Kestrel Park Cottages

Kestrel Park Subdivision, Area 3

Planning Commission Hearing

February 11, 2020

① NORTH-SOUTH SITE SECTION (typical solar access setbacks)
SCALE: 1/8"=1'-0"

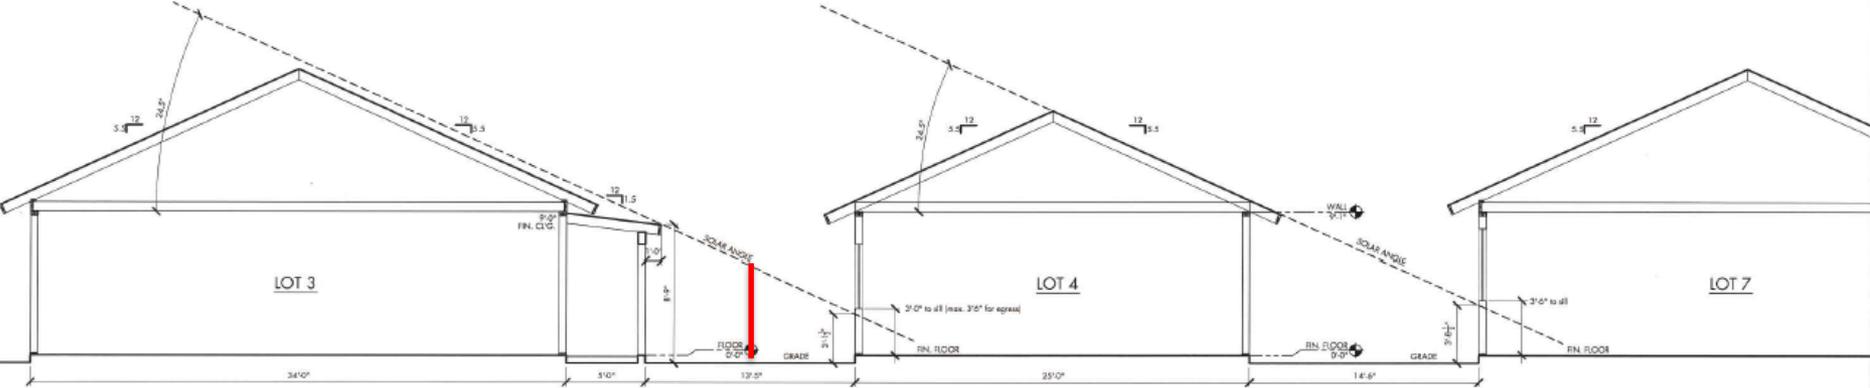
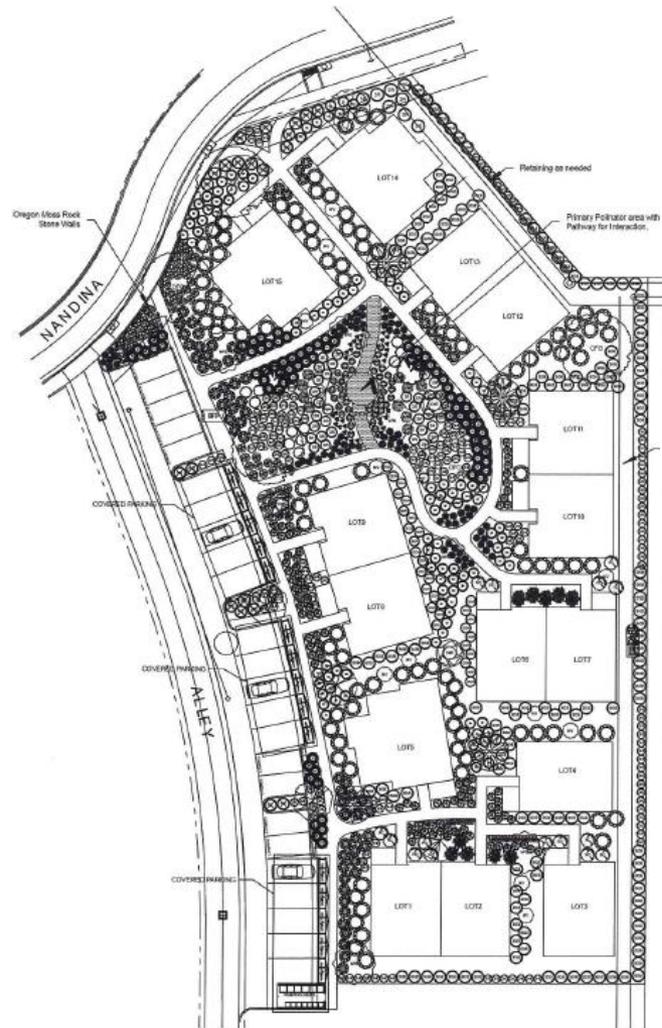
The applicant proposes to address solar access with a performance standard approach to define an allowed shadow height to protect the applicable solar access standard. For a typical lot with a standard six-foot side yard setbacks, a building complying with Solar Access Standard A would be allowed to shade approximately four feet up the wall of a building at six feet from the property line. Performance Standards Subdivisions allows flexibility with regard to setbacks, and the applicant proposes to preserve solar access comparable to ‘Standard A’ by allowing the shadow cast by a southern unit to extend no more than four feet above the finished floor of the adjacent building to the north, regardless of the property line location relative to the buildings. This means that the lowest windows would not be shaded and therefore living space within the house would retain the benefits intended by the solar access standards.
